Access Compliance Report Public Rights-of-Way (Curb Ramps)

Main Street: EL_CARMEN_AVE Cross Street: HEWES_ST Location: SE

ADA ID: RPAT211020083122 Ramp Type:Type 1 - Perpendicular Diagonal Initial Pass/Fail: Pass Overall Compliance: No Severity Score: 4

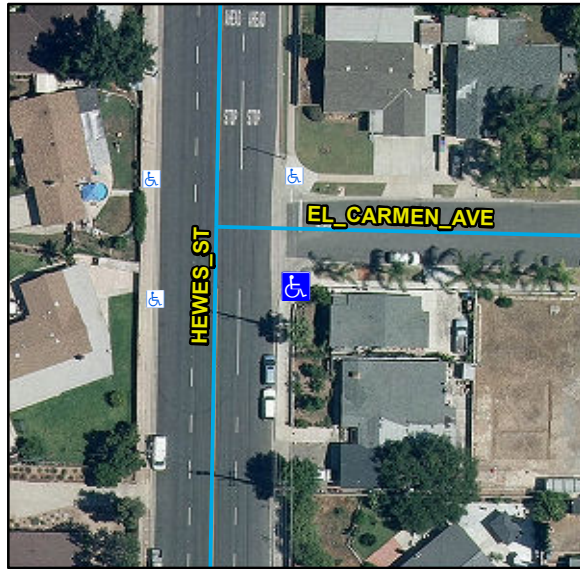
R304.2.2, R304.2.1, R304.2.2-Perp, R304.3.2-Para, R304.5.3, STD 1115

Remove & Replace Curb Ramp With Two New Directional Ramps or Equivalent.
